MULTIQUIP QUARRIES ARDMORE PARK QUARRY

Further Responses to the Department of Planning and Environment re. Mod 3 to PA 07_0155

Compiled by R.W. Corkery & Co. Pty Limited

2008 Environmental Assessment

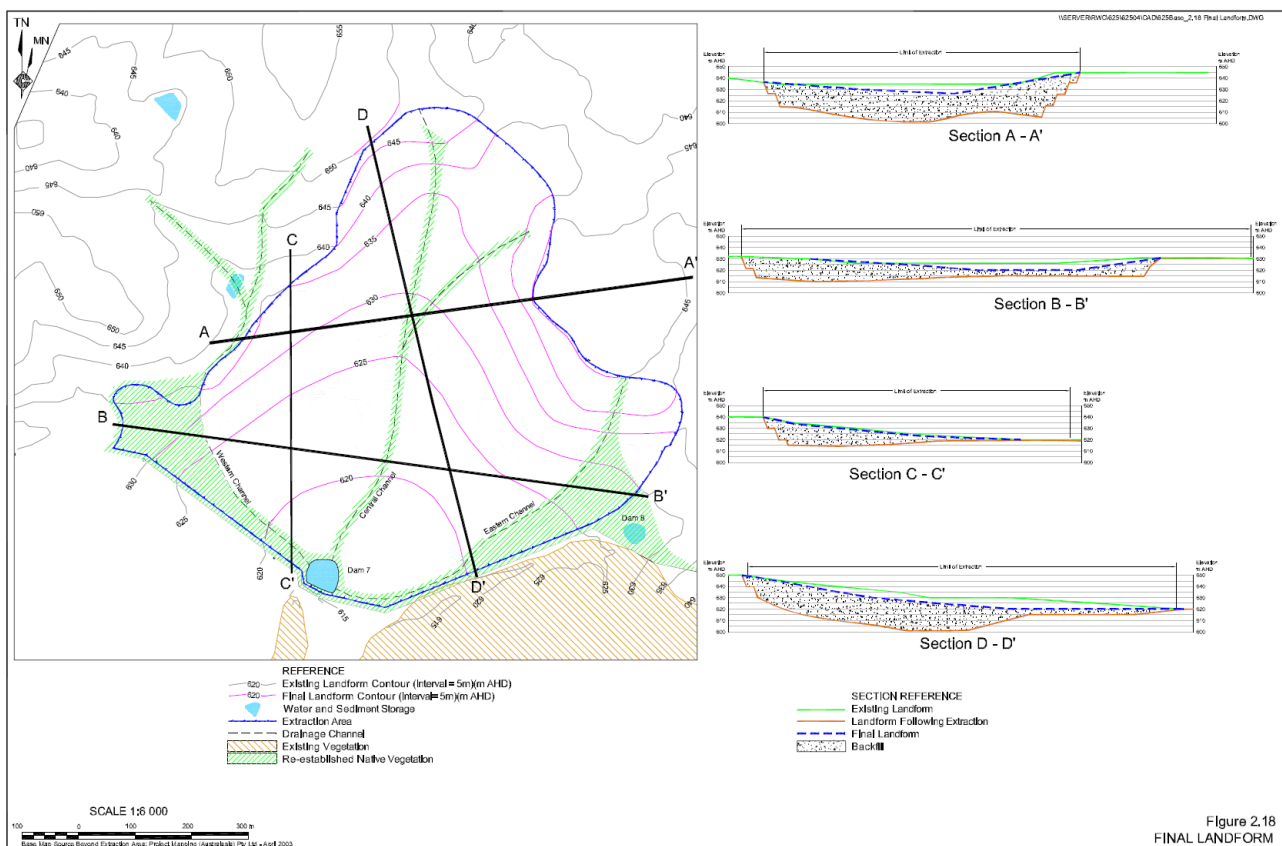
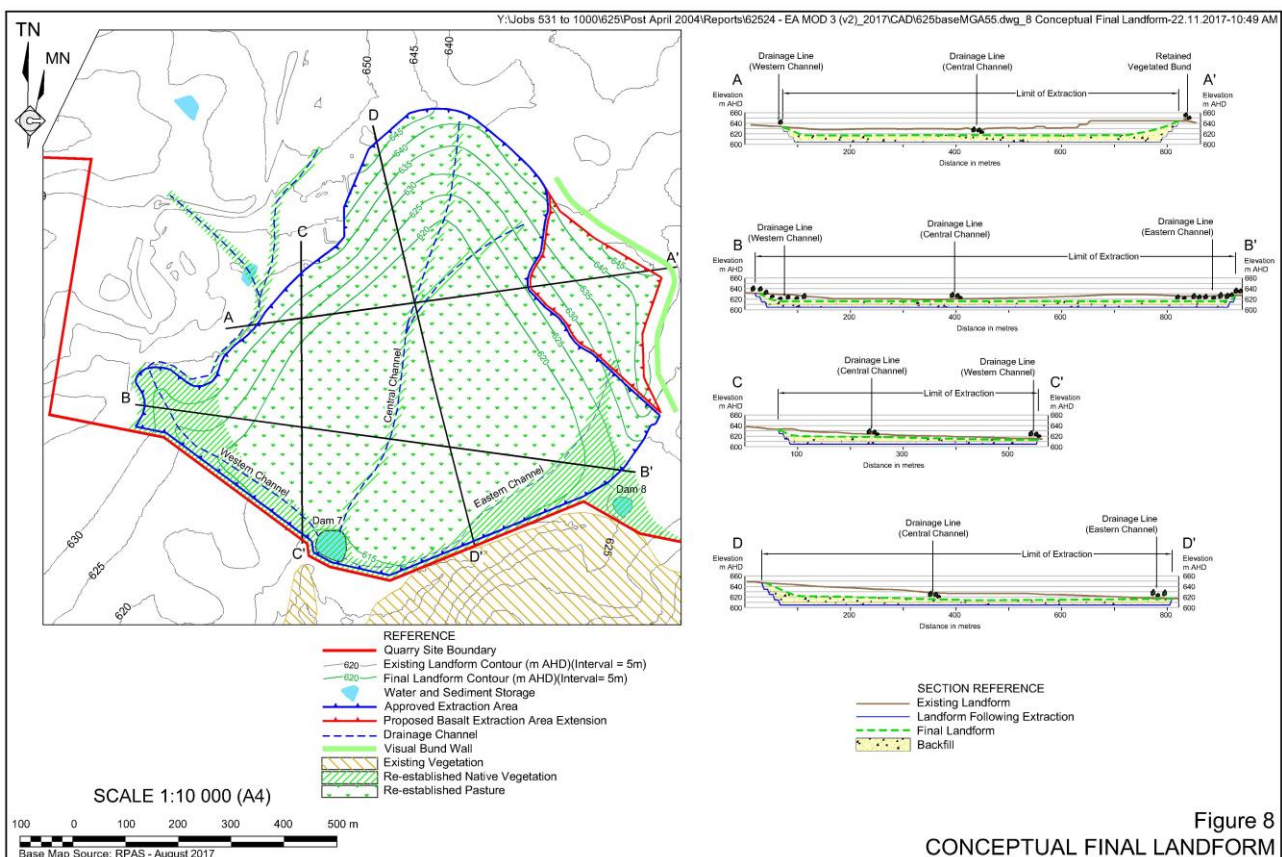
It is noted that the final landform within the 2017 *Environmental Assessment* (**Figure 8** (see following page)) presents a different landform to that originally presented in the 2008 *Environmental Assessment* (**Figure 2.18** (see following page)). The 2017 final landform will require a total of approximately 3.7 million m³ of materials to achieve the final landform displayed. This volume of material is approximately 1.9 million m³ less than that previously required to achieve the 2008 final landform.
